\Groundwater Transfer Review Summary Form

Transfer/PA # T- 14892

Application: T-14892

Applicant Name: Gregg Ditchen, Carol Ditchen

Theis Interference Analysis

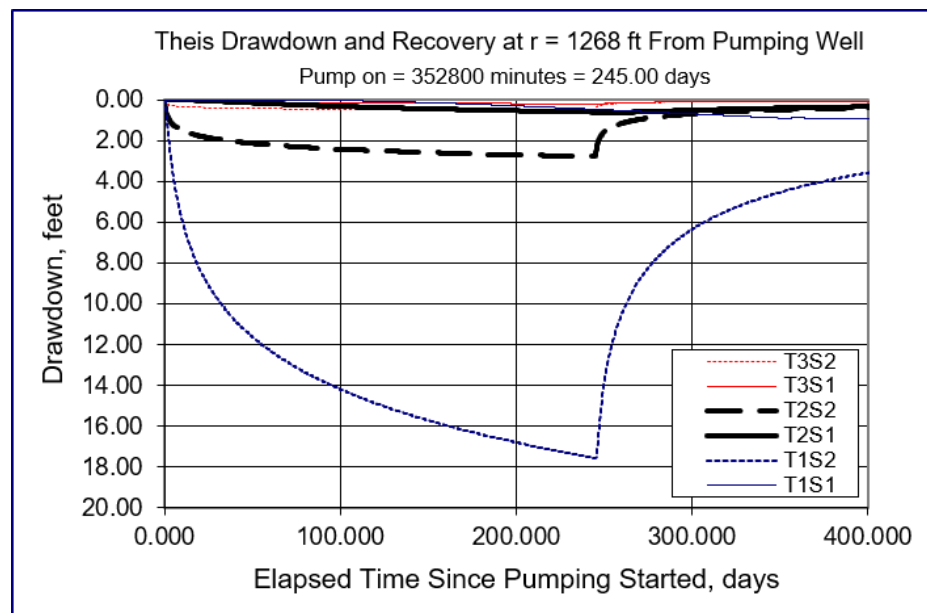
- b) If yes, would this proposed change, at its maximum allowed rate of use, likely result in another groundwater right not receiving the water to which it is legally entitled?
☐ Yes ☒ No If yes, explain: The Theis (1935) solution for drawdown was used to assess the potential for injury to MARI 65374 from the proposed changes (see attached Theis Interference Analysis). Results indicate the proposed change is unlikely to result in MARI 65374 not receiving the water to which it is legally entitled

The to-POA (MARI 3241) could not pump the maximum total rate of 1.86 cfs (835 gpm) for the full duration of the authorized time period without exceeding the maximum volume of 64.25 AF. The averaged rate of 0.132215 cfs (59 gpm) would provide 64.25 AF over the 245-day irrigation season and is used.

SWL	90 ft bls	MARI 65374
Aquifer Bottom	207 ft bls	Woodward et al., 1998
Available Water Column	117 ft	Aquifer bottom-SWL
Pump Height Above Bottom	5 ft	Estimate
NPSHa	5 ft	Estimate
Drawdown	30 ft	Estimate
Minimum Water Column	40 ft	Estimated Drawdown + NPSHa + Pump Height
Injury	77 ft	Available Water Column-Minimum Water Column
